Service Action: Replace Neck Warmer Control Unit

F33 (4 Series Convertible)

F83 (M4 Convertible)

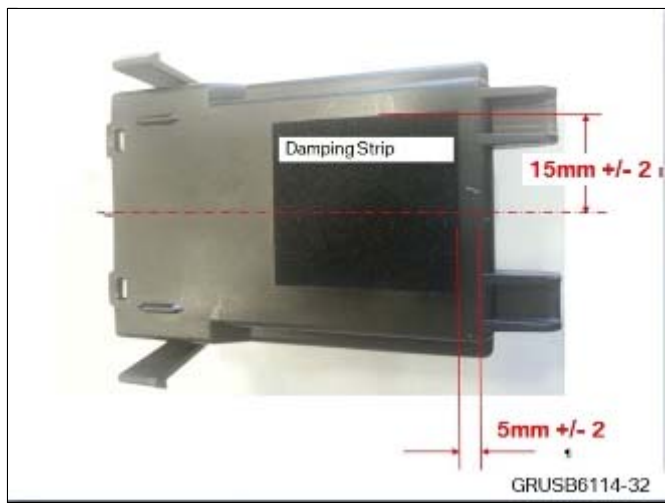
1. The control unit is located under the rear seat bottom, as shown in the photo, and is clipped in place.
2. Unplug the two electrical connectors and remove the neck warmer control unit.

3. Prior to installing the new control unit, install a damping strip (self-sticking) onto the back side of the control unit in the position shown.
4. Plug in the electrical connectors and install the new control unit.

Replace the neck warmer control unit and install the damping strip.
